UNITED STATES  
NUCLEAR REGULATORY COMMISSION  
WASHINGTON, D. C. 20555

SUBJECT: ST. LUCIE UNIT 1 - ISSUANCE OF AMENDMENT RE: SPENT FUEL POOL  
EXPANSION (TAC NO. 65589)

SAFETY EVALUATION  
BY THE OFFICE OF NUCLEAR REACTOR REGULATION  
RELATING TO THE RERACKING OF THE SPENT FUEL POOL  
AT THE ST. LUCIE PLANT, UNIT NO. 1  
AS RELATED TO AMENDMENT NO. 91 TO UNIT 1  
FACILITY OPERATING LICENSE NO. DPR-67  
FLORIDA POWER AND LIGHT COMPANY  
DOCKET NO. 50-335

FIGURE 10  
 FUEL RACK MODEL SHOWING  
 RACK-TO-RACK IMPACT SPRINGS

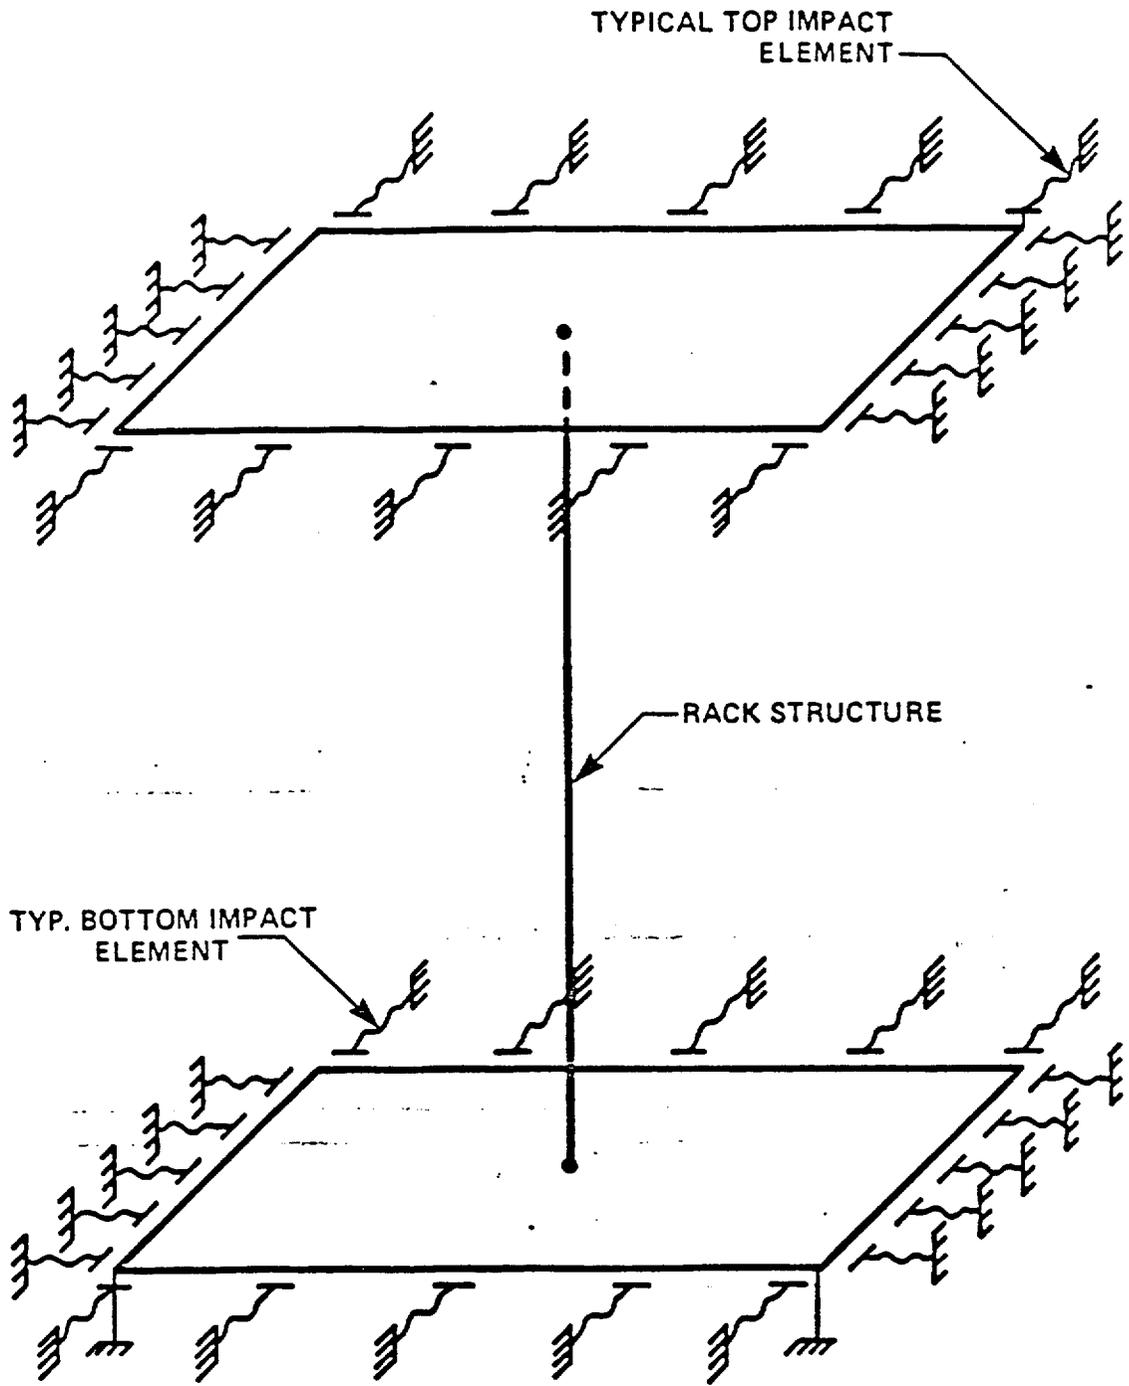
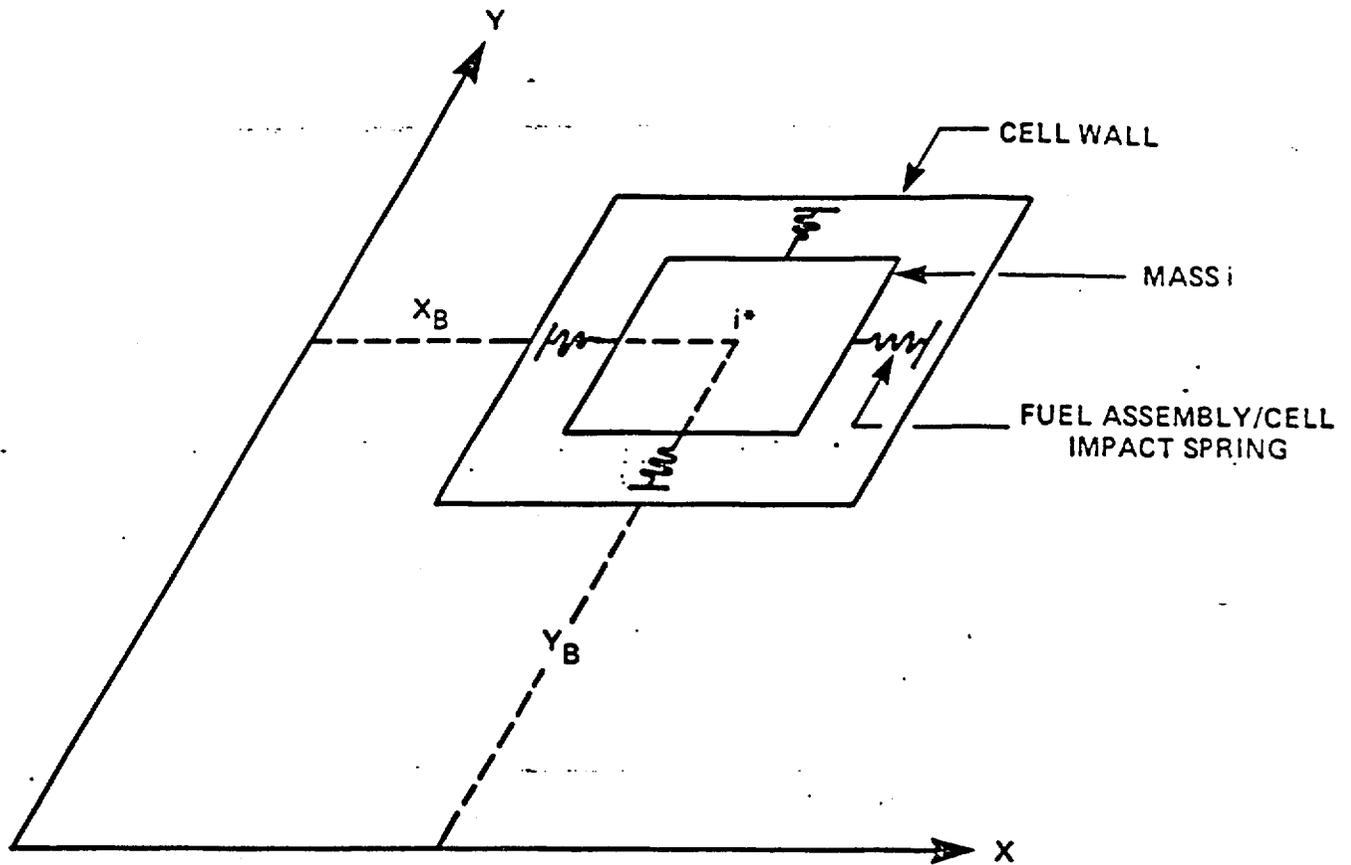
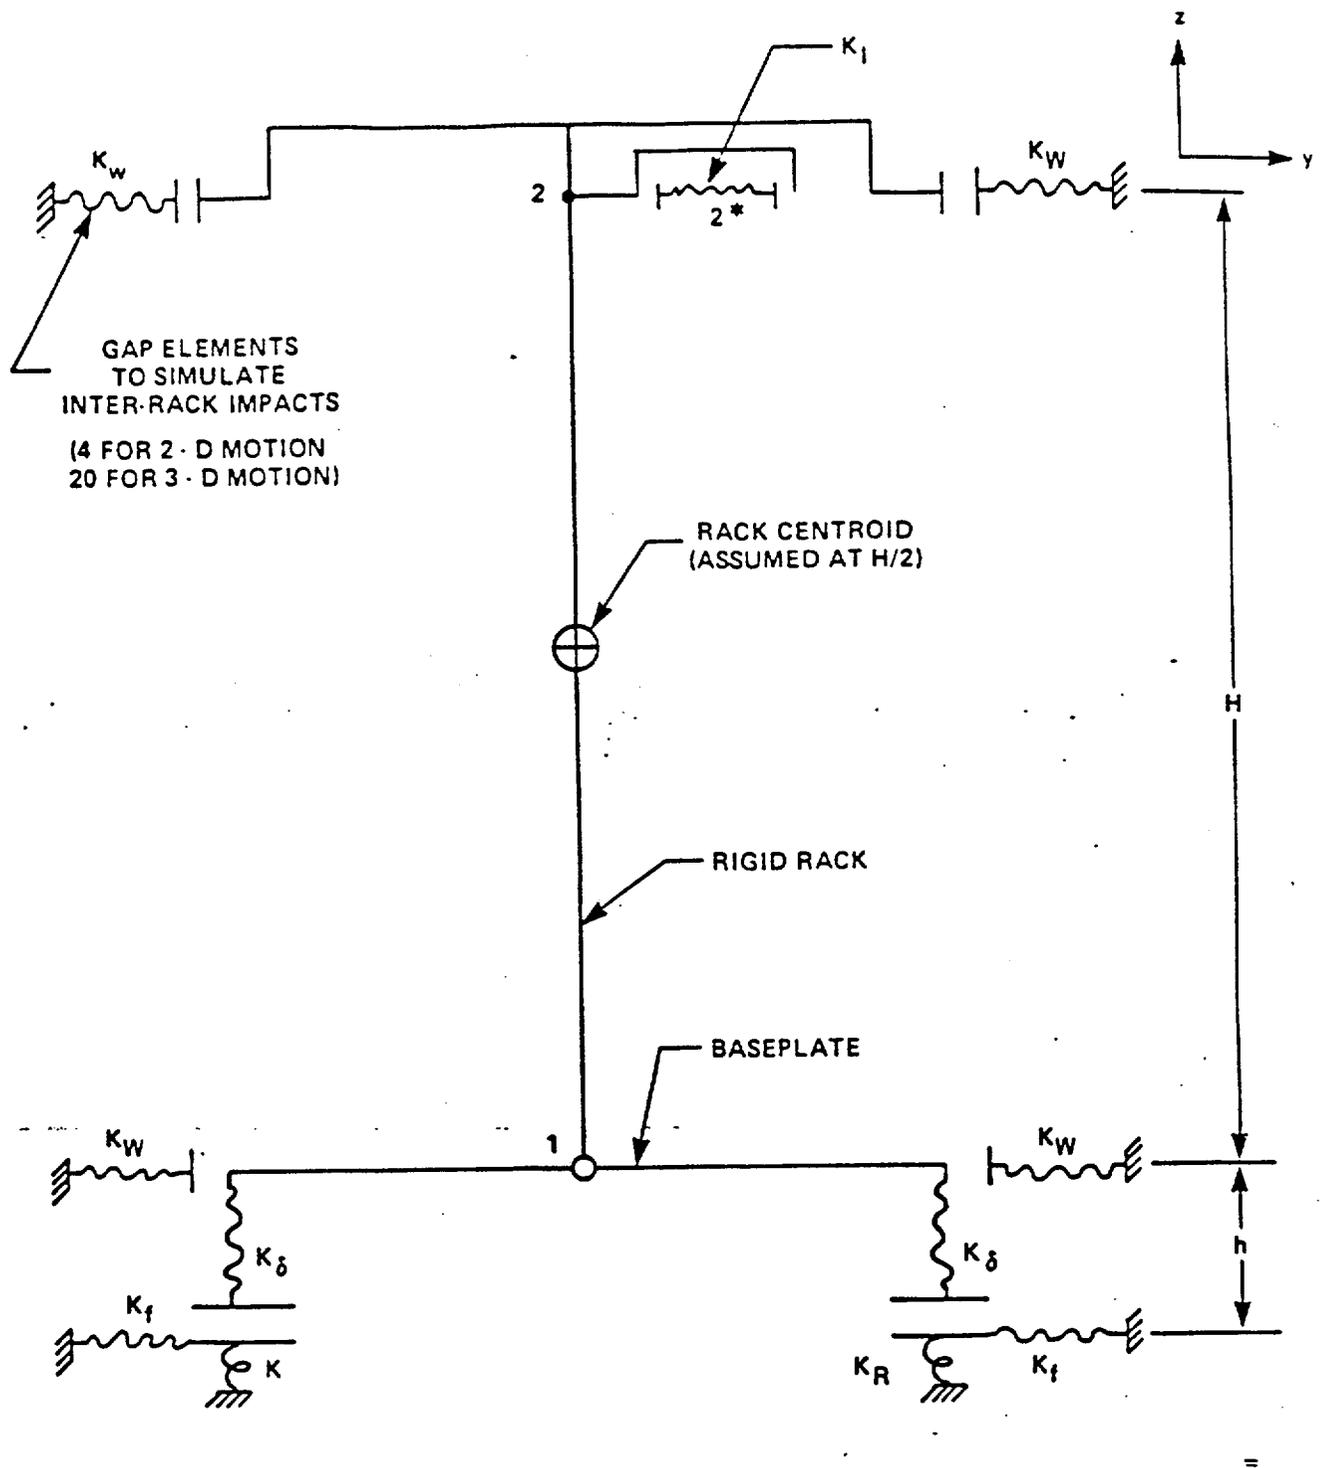
The Licensee's mathematical model of a spent fuel racks module is shown in Figures 9, 10, 11, and 12. The Licensee indicated that the rack structure is very rigid and that its motion can be characterized in terms of six degrees of freedom at the rack base. Figure 9 shows the rack as a rigid stick on a rigid base with three translational ( $q_1, q_2, q_3$ ) and three rotational ( $q_4, q_5, q_6$ ) degrees of freedom. The fuel assemblies are treated as five lumped masses located at different elevations (nodes 1\* to 5\*). All fuel assemblies in a rack module are assumed to vibrate in phase. Each lumped mass is assumed to rattle independently within the rack cell gaps and is represented by two horizontal translational degrees of freedom. Impacts between the rack and fuel assembly lumped masses are accounted for by the use of compression-only gap elements as shown in Figure 11. The support legs are modeled as compression-only springs (S1 to S4 in Figure 9) which consider the local vertical flexibility of the rack-support interface. Friction elements are used at the bottom of the support legs. Figure 10 shows the impact springs acting through gap elements to simulate the interface with adjacent rack modules or pool walls. Five impact springs per side are used at both the girdle bar and baseplate elevations. Figure 12 shows a two dimensional representation of the model with only one "rattling" fuel mass to clarify the overall model concept.

The adequacy of analyzing only a single rack model in the seismic analysis was questioned. The seismic motion of a single rack is coupled to the motion of adjacent racks through impact forces and fluid coupling forces. The single rack model constrains the motion of a rack within an imaginary boundary. Maximum displacements cannot exceed one-half the gap to the adjacent racks. For sufficiently strong seismic motion, sliding and tilting motions of the racks could be larger than those predicted by a constrained single rack model resulting in higher impact velocities than would be predicted by a single rack model. Under worst conditions, rows of racks could slide together in one direction and pile up against a pool wall. The additional mass of racks involved in the impact could generate larger loads on the racks and the pool walls. This concern may be more critical for the pool walls, since they are not designed to accommodate seismic impact loads from the fuel racks. In response to these concerns, the Licensee committed to perform a two dimensional multiple rack analysis of a single row of fuel racks to determine the extent of rack displacement under an SSE. The results and evaluation of the multiple rack analysis is discussed in Section 4.2.2.

Several questions were raised regarding the conservatism of the fluid coupling parameters used in the analysis: (1) The Fritz approach makes the assumption that the vibratory deflections are small relative to the size of the gaps. This assumption does not correspond to the conditions that would prevail during an earthquake where the rack-to-fuel and rack-to-rack displacements would be as large as the gaps. Fluid coupling coefficients are calculated on the basis of a constant gap assumption. As fuel racks move away from each other, the coupling coefficients should decrease, resulting in lower fluid coupling forces and possibly higher velocities. (2) The assumption that adjacent racks are vibrating 180 degrees out of phase seems to maximize the retarding effect of fluid forces and reduce the maximum impact velocities of the racks. This can result in unconservative rack-to-rack impact forces. (3) The rack-to-fuel fluid coupling terms were calculated based on the assumption that the fuel assemblies are solid square cross-sectional bodies, and that all of the surrounding water flows in the fuel assembly/cell wall space around the periphery of the fuel. In reality, the fuel assemblies are arrays of fuel rods with gaps between rods. As a fuel assembly vibrates within a cell, water can flow both around and through the fuel. The resulting fluid coupling forces can then be much lower than predicted by this model.

NORTH - SOUTH SSE  
FIGURE 13

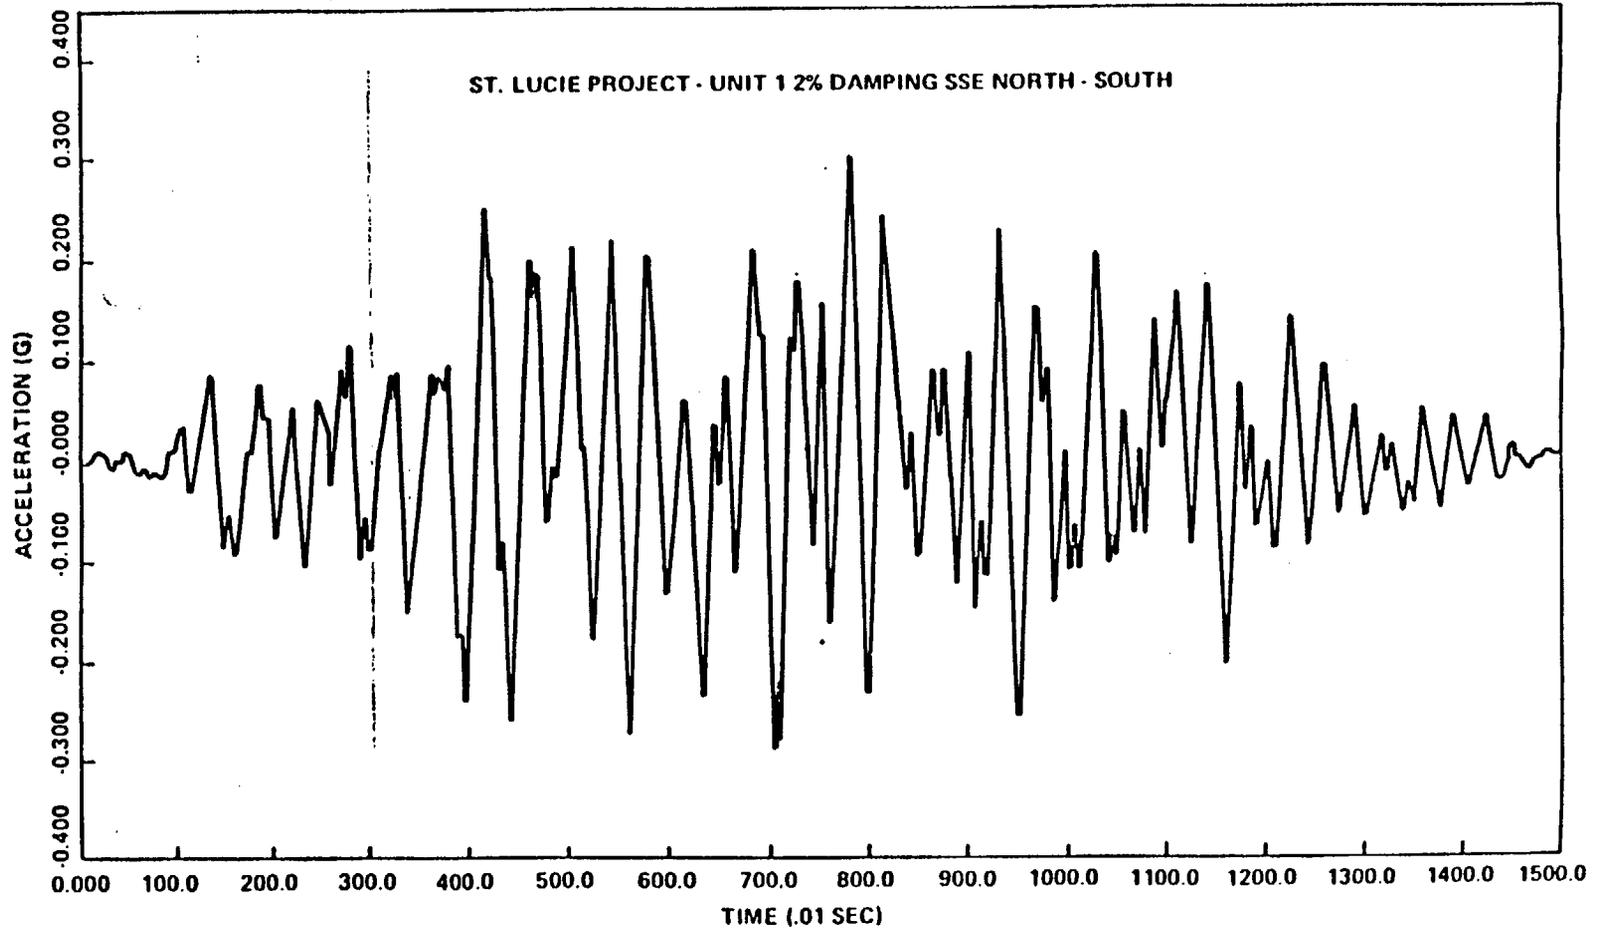
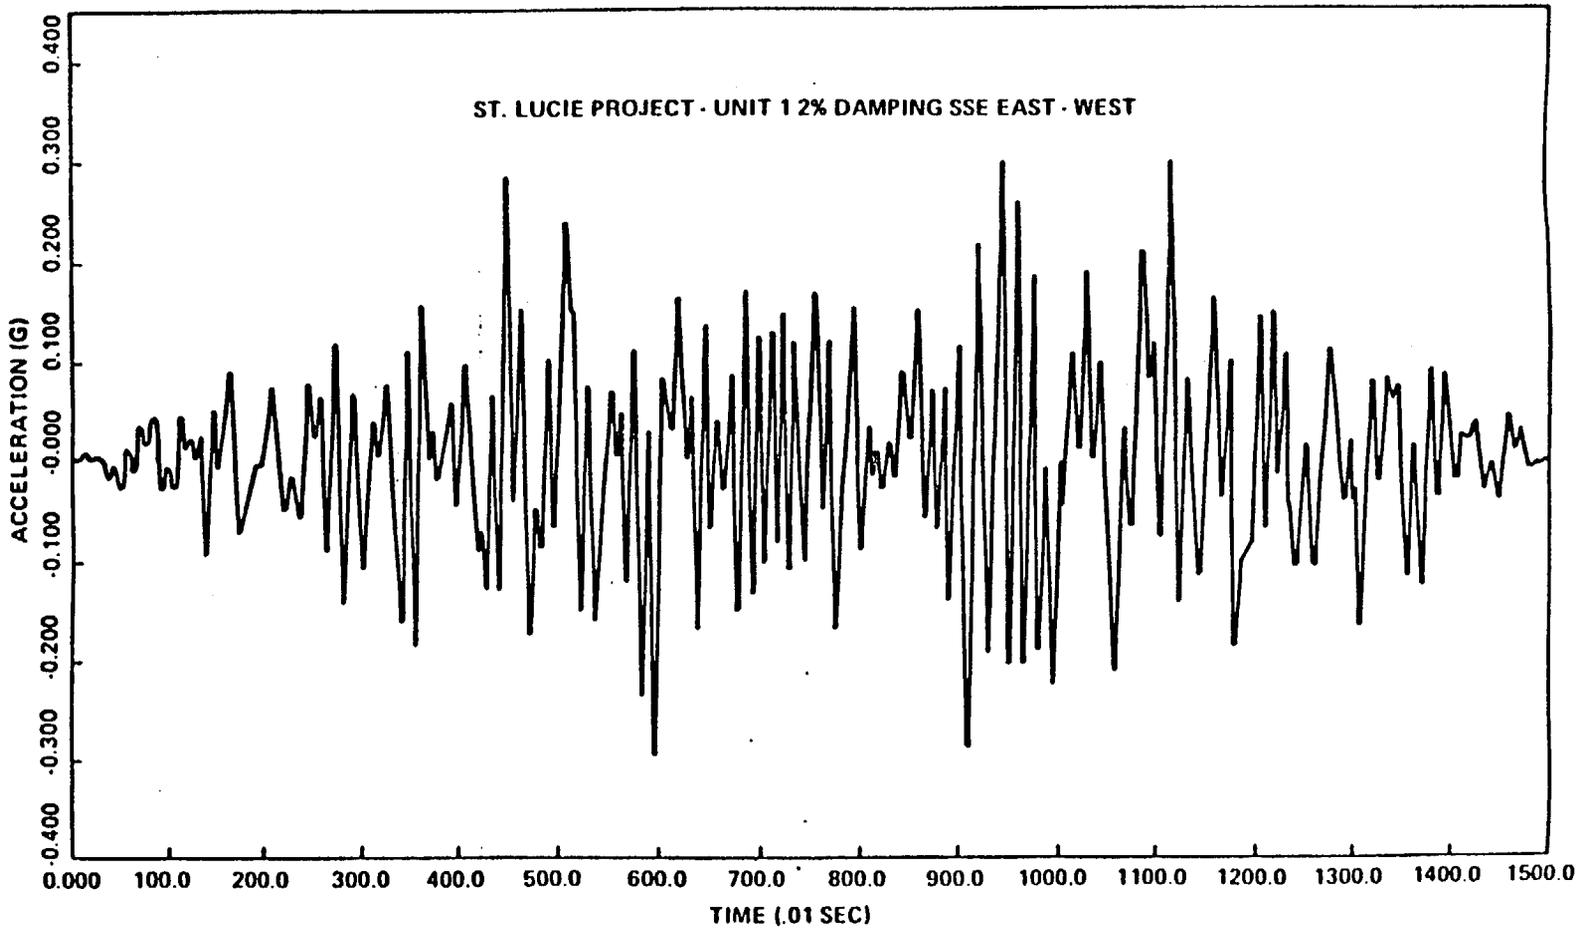
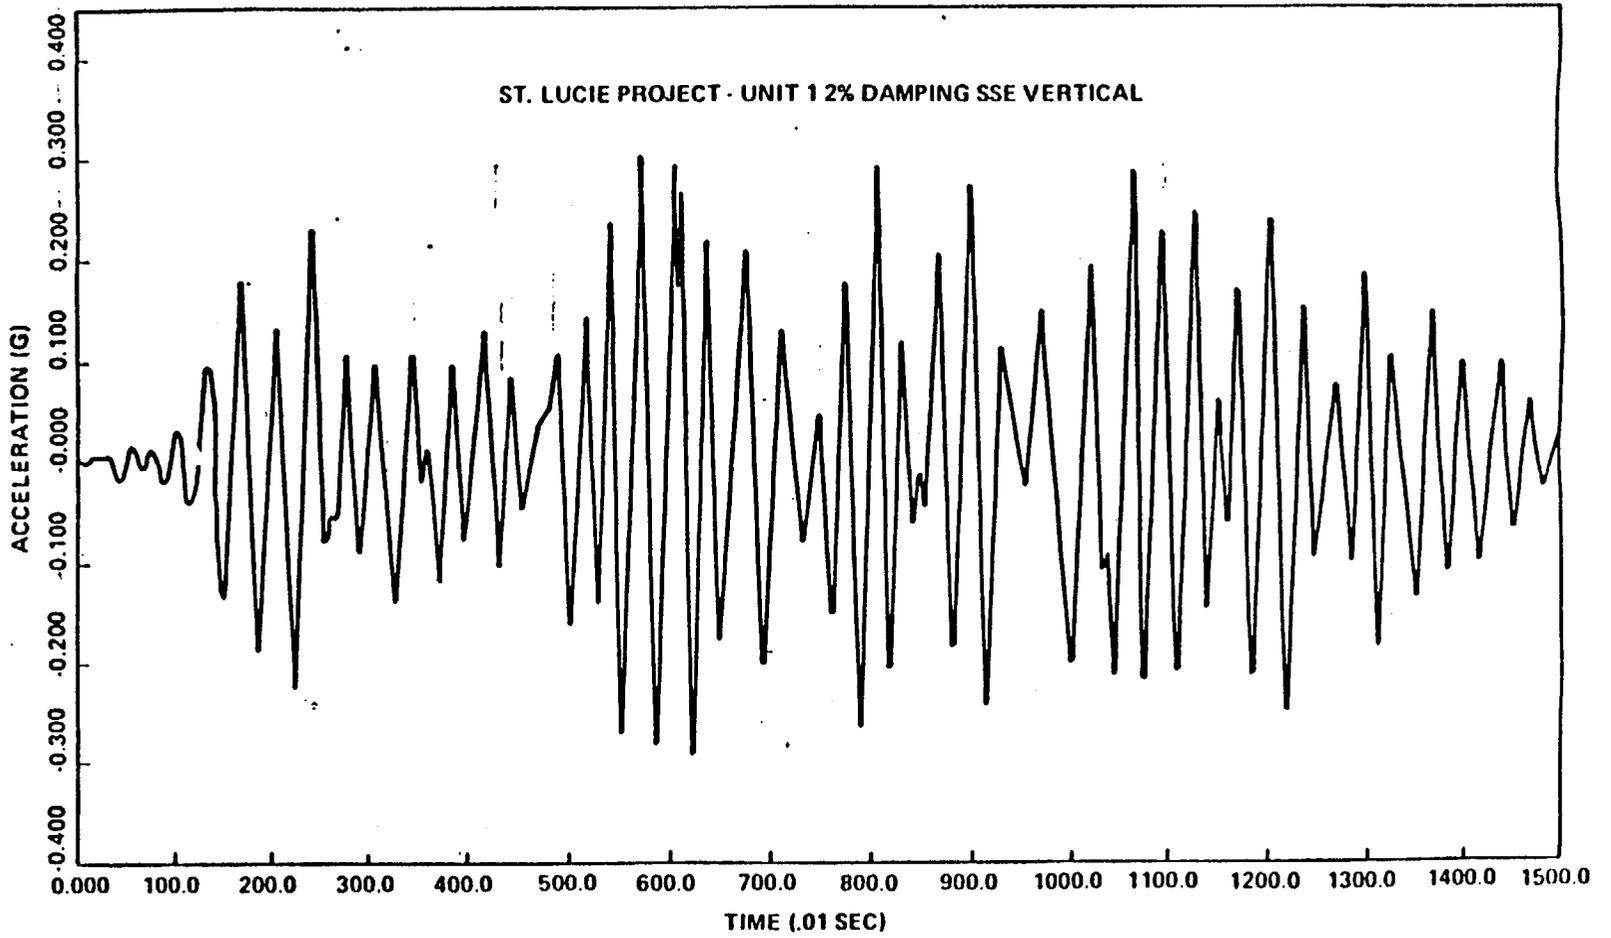
The revised response spectra were used to generate statistically independent acceleration time histories, one for each of the three orthogonal directions. A computer program was used to generate the artificial time histories as a sum of sinusoidal waves. The program used an iteration approach whereby the calculated response provided by the simulated seismic excitation was compared with the "target" design response spectrum. The amplitudes of the sine waves were modified at each iteration step so as to obtain the best agreement at certain control frequencies specified by the user. The resulting time histories used in the fuel rack analysis are shown in Figures 13 to 15.

The Licensee was asked to provide a comparison of the design response spectra with the artificial time history response spectra. This comparison was provided in terms of velocity response spectra plots in Reference 3a. The plots showed reasonable agreement between the calculated curves and the design curves.
